#### **Addendum 43 – Regulation No. 44**

#### **Revision 3 - Amendment 3**

Supplement 10 to the 04 series of amendments – Date of entry into force: 18 June 2016

#### **Uniform provisions concerning the approval of restraining devices for child occupants of power-driven vehicles ("Child Restraint Systems")**

Figure 1  
Procedure type 1

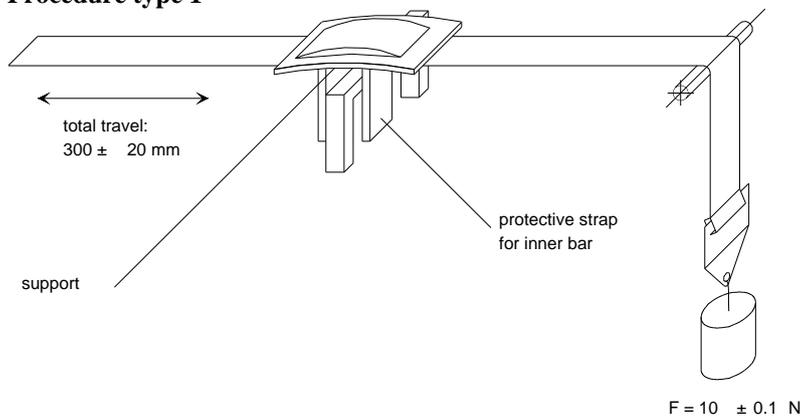
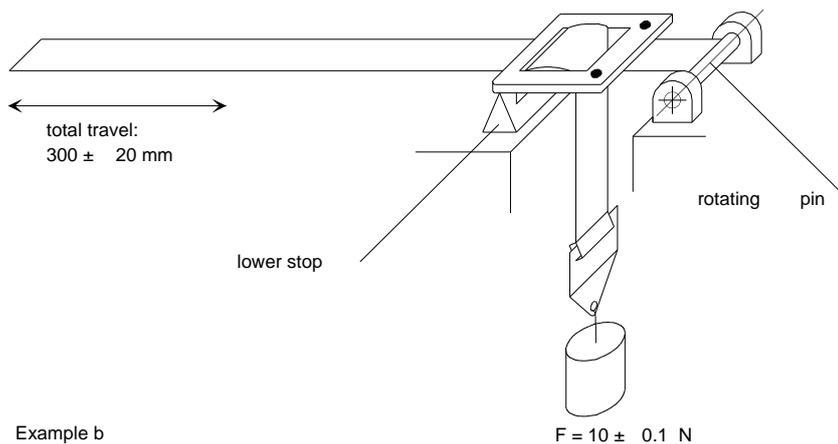
Annex 5, amend to read:

Remark.  $F = 10 \pm 0.1$  N, can be increased up to  $F = 60 \pm 0.5$  N

8.2.5.2.6.3.1. Type 1 procedure: for cases where the strap slides through the quick adjusting device. Apply a load of 10 N, if necessary the load may be increased by 10 N steps so as to permit correct sliding, but limited to a maximum of 60 N. This load shall be vertically and permanently applied on the straps. The part of the strap set horizontally shall pass through the quick adjuster it is fitted to and shall be attached to a device, giving the webbing a back and forth motion. The quick adjusting device shall be so placed that the horizontal strap of the webbing remains under tension (see Annex 5, Figure 1). Activate the quick adjuster while pulling the straps in the direction to slacken the harness and deactivate it while pulling the straps in the direction to tighten the harness.

Figure 2  
Procedure type 2  
Following two examples of test set up

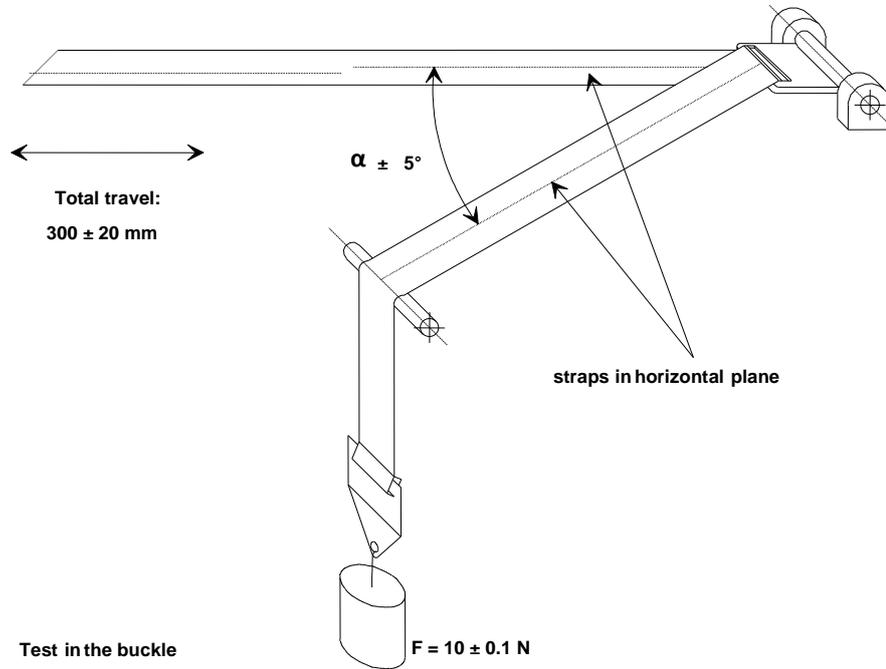
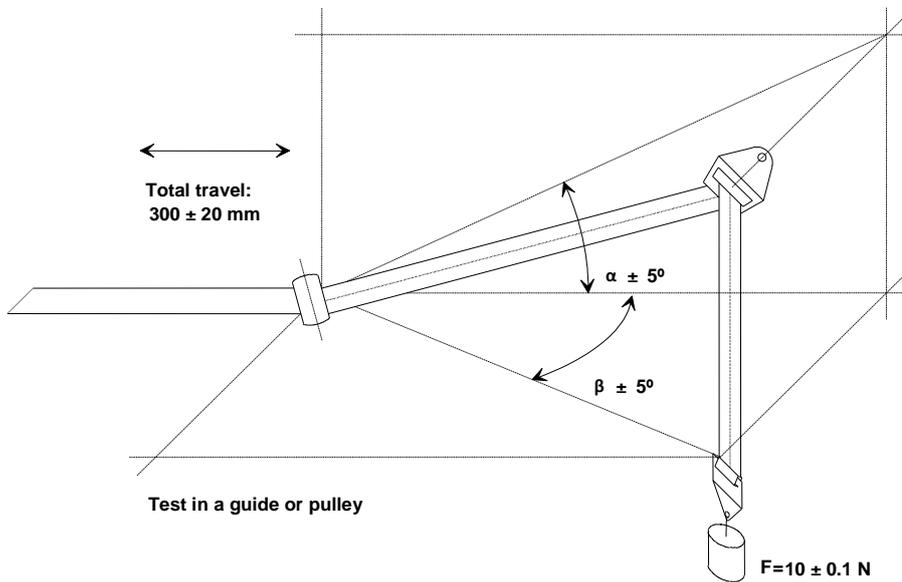
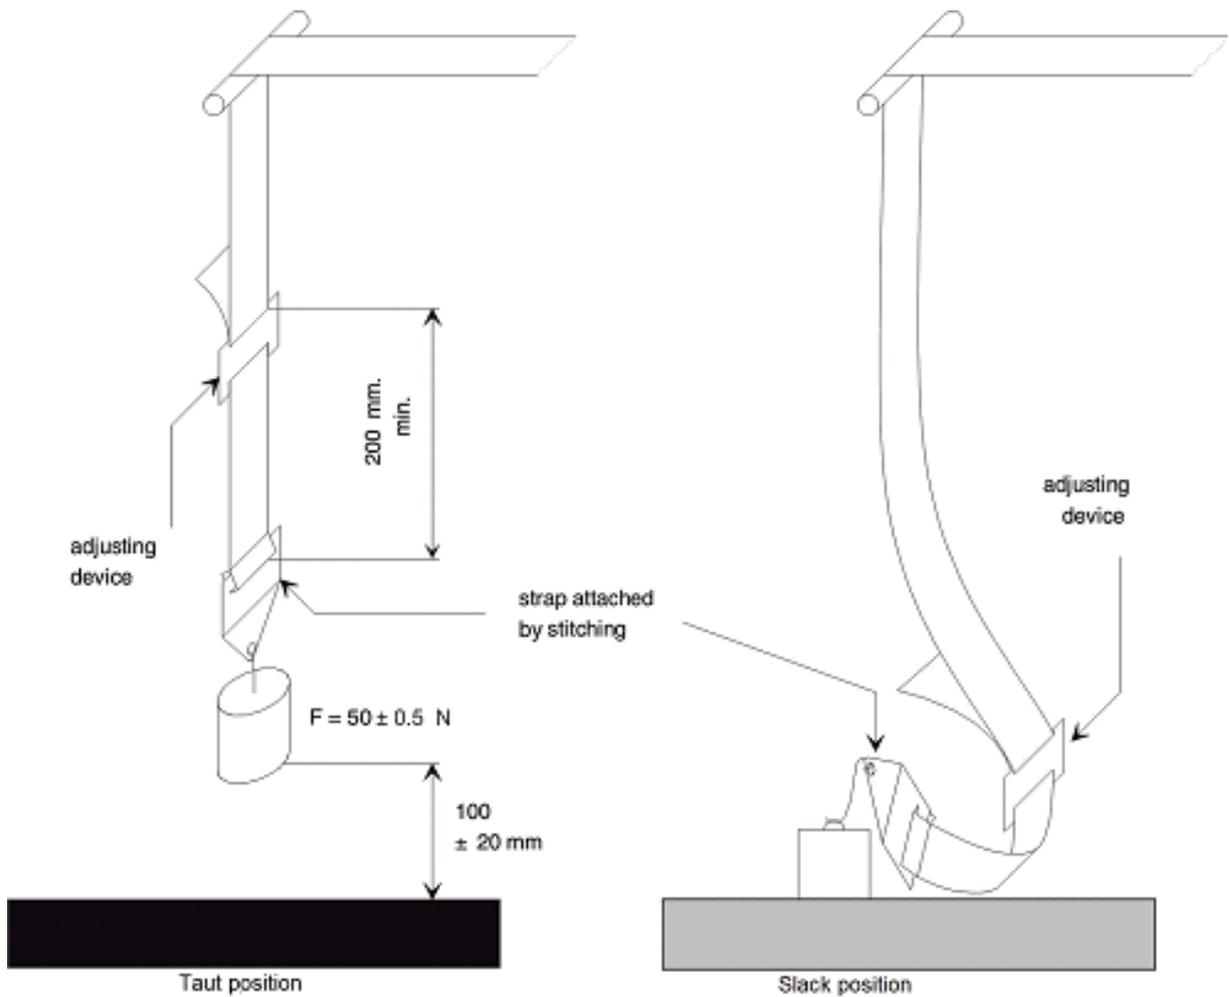
Where  $\alpha$  and  $\beta$  reproduce the angles as in the real installation (in three dimensions).

The load of 50 N on the testing device shall be vertically guided in such a way as to prevent load-swing and twisting of the strap. The attaching device shall be fixed to the load of 50 N in the same manner as in the vehicle."

8.2.5.2.6.3.2. Type 2 procedure: for cases where the strap changes direction in passing through a rigid part. During this test, the webbing shall pass through the rigid part it is intended for and the test set up shall reproduce the angles as in the real installation (in three dimensions), see Annex 5, Figure 2 for examples. The 10 N load shall be permanently applied. For cases where the strap changes direction more than once in passing through a rigid part, the load of 10 N may be increased by 10 N steps so as to permit correct sliding and achieve the prescribed 300 mm of strap movement through that rigid part."

Figure 1  
**Examples of completely recessed support leg**

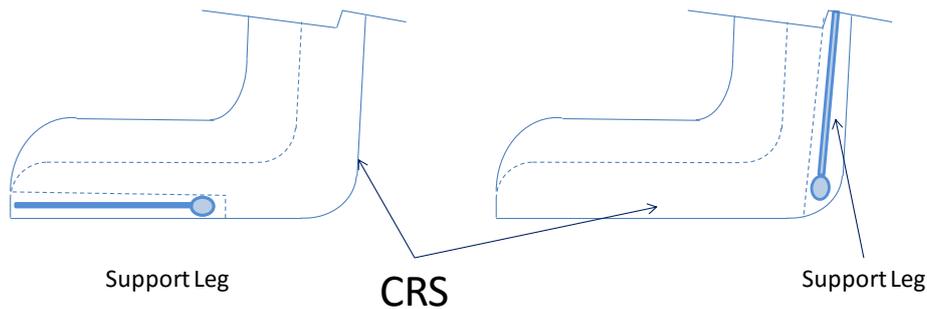
Insert new explanatory notes on paragraphs 7.1.4.1.4., 7.1.4.1.10.1.2., 8.1.3.6.3.2. and 10.1.3., respecting the numerical order, to read:

Completely recessed means that with the leg in the stowed position, no part of the leg protrudes beyond the surface of the base or shell, such that it has no effect on the position of the CRS on the test bench. See the following figures for clarification examples.

- "7.1.4.1.10.1.2. Without the anti-rotation device in use. If the anti-rotation device is a support leg and it can be completely recessed within the base or the shell of the CRS, the test is conducted with the device in its stowed position or with the leg removed respectively. If it cannot be completely recessed within the base, the test is performed with the device deployed in its shortest length with the trolley floor pan in its lowest position.
